**Re:** Proposed Limerick City Greenway (UL to NTP)

**ACP REF. NO.: ACP-323410-25**

# Planning Submission

**Proposed Limerick City Greenway (UL to NTP)**

Plate 2: Figure 2.3 of Chapter 2 of the EIAR Part 2

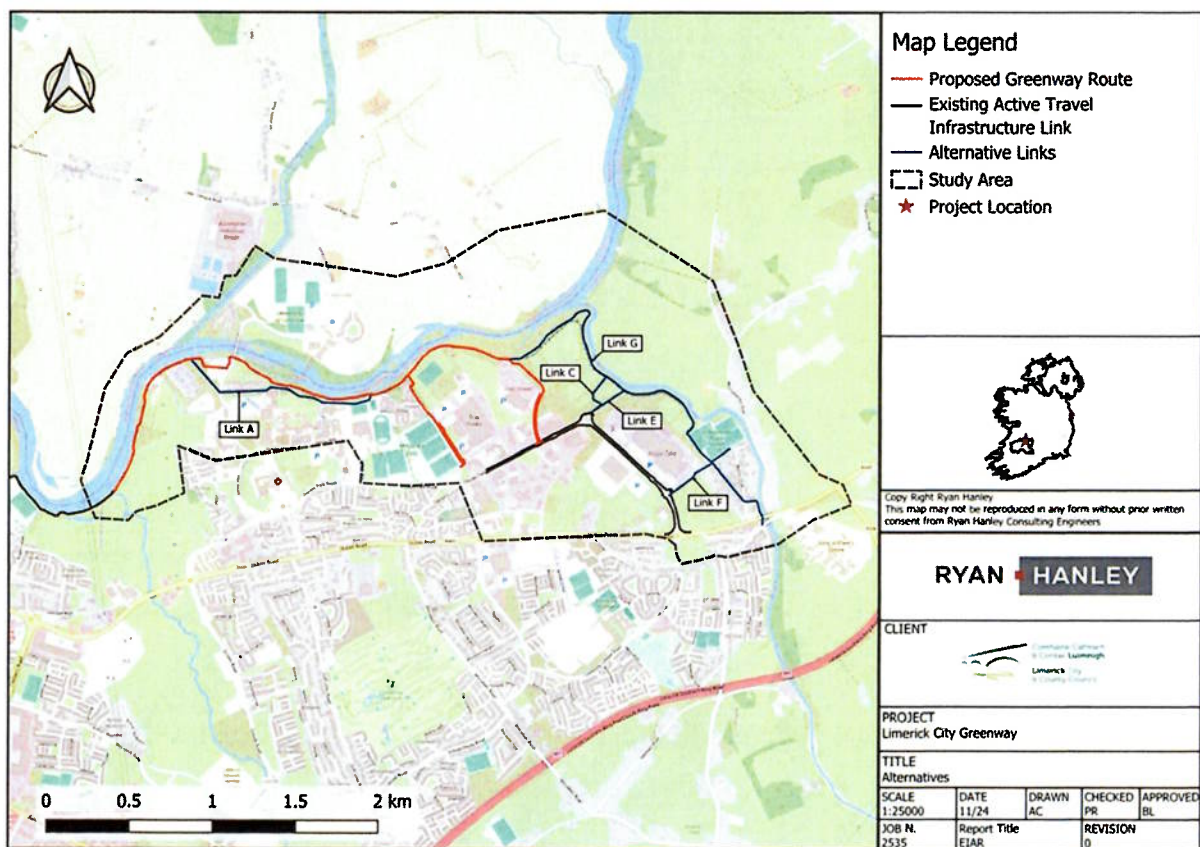
- 3.2.4 It is submitted that the route of the path at this location should be determined on foot of an environmental assessment that is technologically, socially, environmentally, and economically acceptable. In this context, we note Figure 2.3 of Chapter 2 of the EIAR Part 2, excerpt in Plate 3, which illustrates the alternative route options considered.
- 3.2.5 The reasonable alternative of the existing path to the front of the Fisherman Cottages (Plates 3-4) is not assessed. It is noted in section 2.4.2 of Chapter 2 of the EIAR Part 2 that, in accordance with the EU Guidance Document (EU, 2017), *an alternative should not be ruled out simply because it would cause inconvenience or cost to the Developer.*

3.2.6 There does not appear to be an environmental reason to rule out the alternative option of using the existing path to the front of the Fisherman Cottages. It is considered that the lack of environmental assessment of this reasonable alternative is a weakness in the application. The removal of existing trees to facilitate the preferred option does not appear to be justified in this context. The provision of replacement planting to compensate for the removal of these trees is also, therefore, not justified. In addition, the proposed greenway bisects a meadow on University land, which is an established amenity area, and contains mature trees. This section of preferred route appears to have a higher potential for environmental impact than the alternative existing route and is therefore not in the interests of the proper planning and sustainable development of the area. In addition, the proposal to instal a berm to address concerns raised by residents of the Fisherman Cottages in relation to flooding can be facilitated in the alternative existing route.

3.2.7 In this context, we respectfully request the Commission to request the applicant to submit revised proposals that either:

- Incorporate the use of the existing route to the front of the Fisherman Cottages for that section of the proposed development (the preferred option from the University's perspective), or
- Incorporate the use of the existing route along the Millstream, connecting back to existing University roads, avoiding the meadow altogether.

**Plate 5: Proposed alternative options to avoid unnecessary impact on University lands**

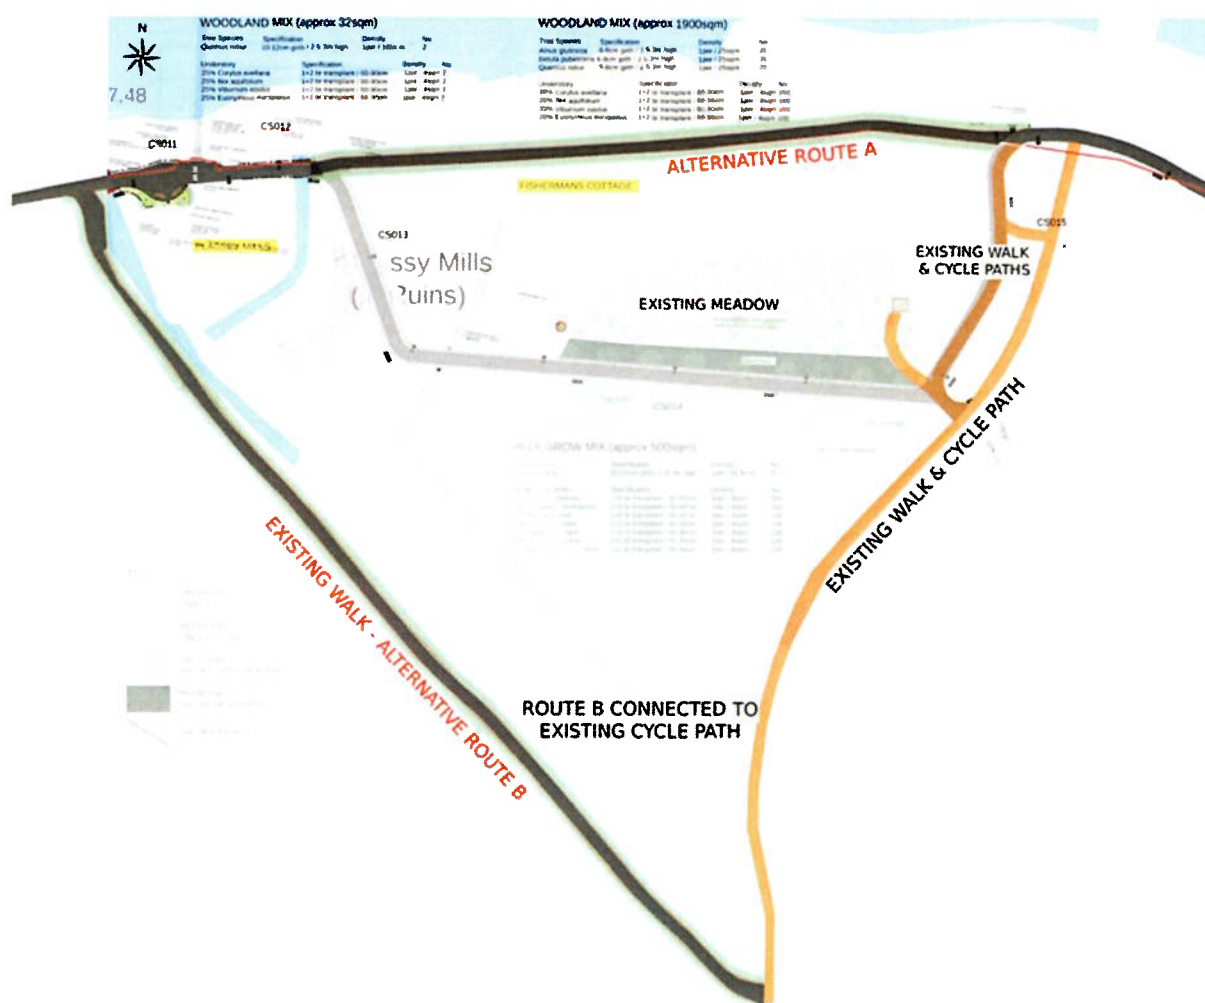
Plate 5 below illustrates these alternative options. Plates 6 and 7 depict sections of the existing path along the Millstream.

**Plate 9: Excerpt of Figure 6-102 of the Planning Application Report**

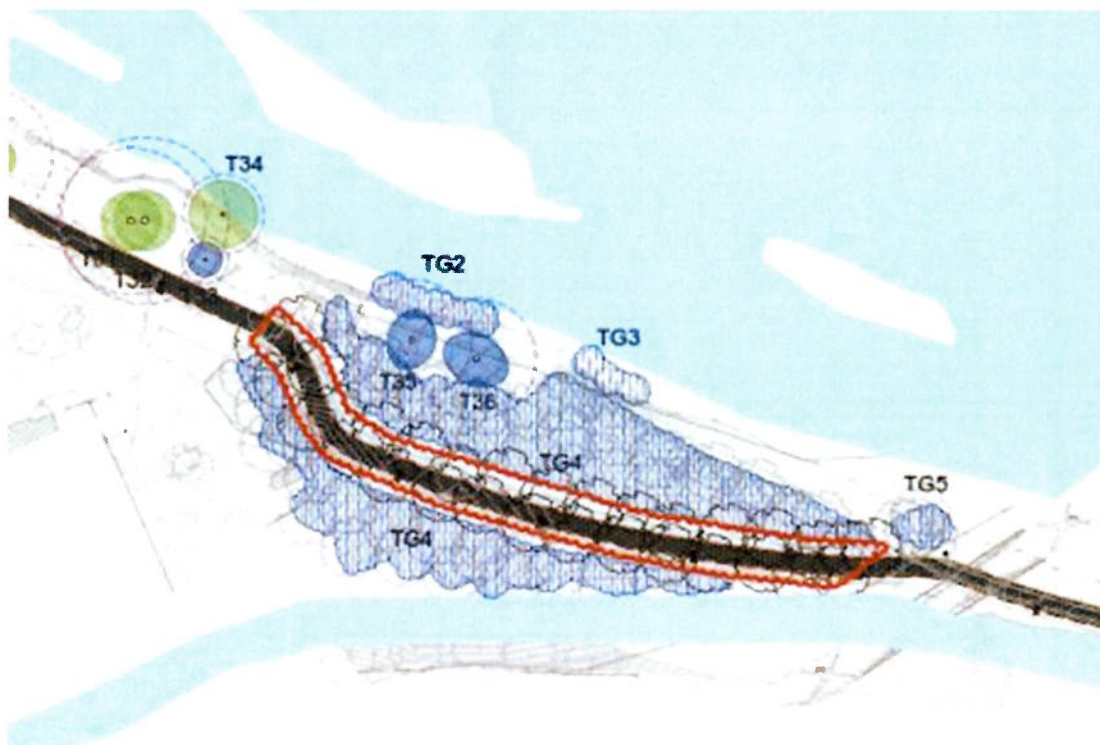
- 3.3.2 However, the trees to be removed, of which there is a significant quantum, have been characterised as being of moderate quality by the project Arborist, i.e., they represent *'Trees present in numbers, usually growing as groups or woodlands, such that they attract a higher collective rating than they might as individuals; or trees occurring as collectives but situated so as to make little visual contribution to the wider locality'*. Figure 6-102 of the Planning Application Report, excerpt in Plate 9 below, illustrates the area of moderate quality trees to be removed.

- 3.3.3 The removal of existing trees to facilitate the preferred option does not appear to be justified in this context. No alternative that avoids the removal of these mature trees is presented in the alternatives assessment. The environmental benefit of this section of the preferred route relative to the loss of this quantum of trees, and the potential impact on the survival of the overall group of trees, is questionable.

- 3.3.4 In this context, we respectfully request the Commission to ask the applicant to submit revised proposals for the section of the proposed development to the west of the Living Bridge that utilises the existing path (Plates 10-11), with a modified route closer to the riverfront that mitigates any impact on the existing Alluvial Woodland, as presented in Plate 12 below:

**Plate 13: Proposed greenway section to the east of Kilmurray Village, the Horticulture building and University Road (CH300\_C-CH677\_C)**

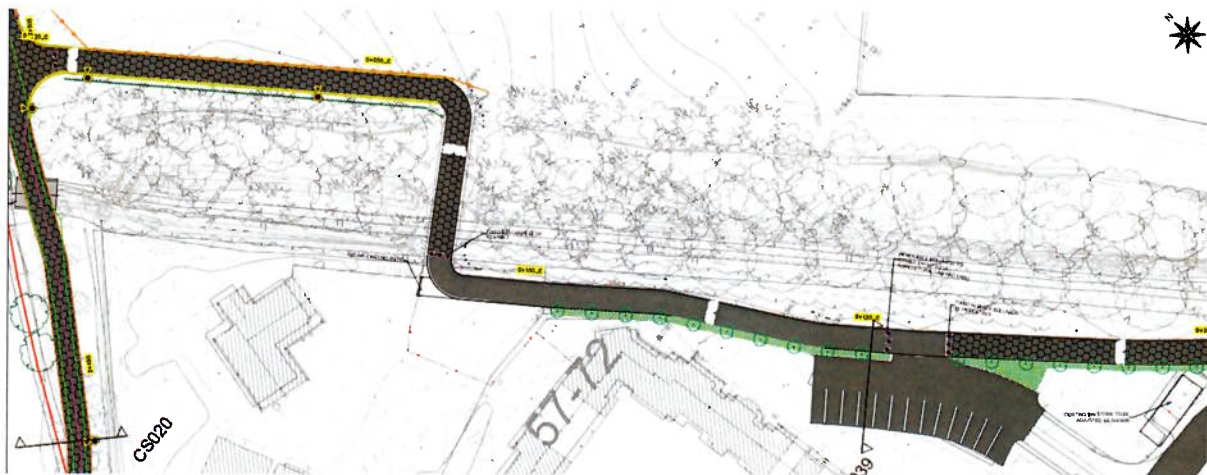
3.4.1 As illustrated in Plate 13, the proposed greenway route as it traverses University Road veers off to the south-east of the UL Horticultural building via an existing access route through an existing wooded area before joining the existing path to the north.

3.4.3 In this context, we respectfully request the Commission to ask the applicant to submit revised proposals for the section of the proposed development to the east of Kilmurray Village, the Horticulture building and University Road, with a modified route that continues straight along University Road to connect to the existing path to the north, as presented in Plate 15 below:

Plate 17: Proposed revised planting regime to the north of Dromroe

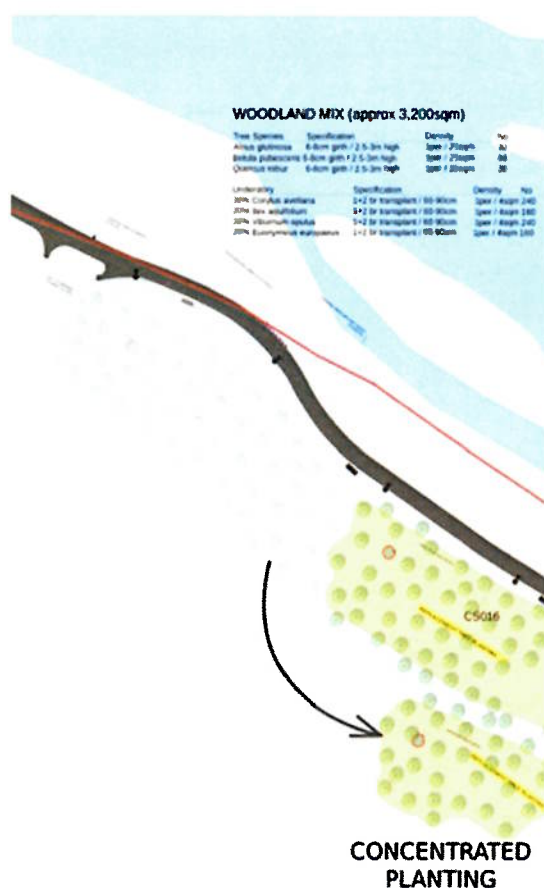
3.5.3 The locations of some of the areas of compensatory planting, for example to the front of Dromroe Student Village, has a negative visual effect on the existing open character and amenities of the area, noting that this area falls within the Castletroy, Dromore Architectural Conservation Area (ACA 9) for which views out from the University's principal buildings are to be safeguarded as per objective 2.9b) of Volume 3 of the Limerick Development Plan 2022-2028, and therefore requires further consideration. In the first instance, however, a fundamental review of the preferred route to reduce the quantum of existing tree removal and avoid the need for large areas of new planting in a somewhat haphazard manner is required.

3.5.4 We respectfully request the Commission to ask the applicant to review the quantum of tree loss and associated compensatory tree planting, and, in the instance of the area to the front of Dromroe Student Village, to reduce the scale of planting, or position the proposed planting further east to avoid any impact on the visual amenities of the area, as suggested in Plate 17.
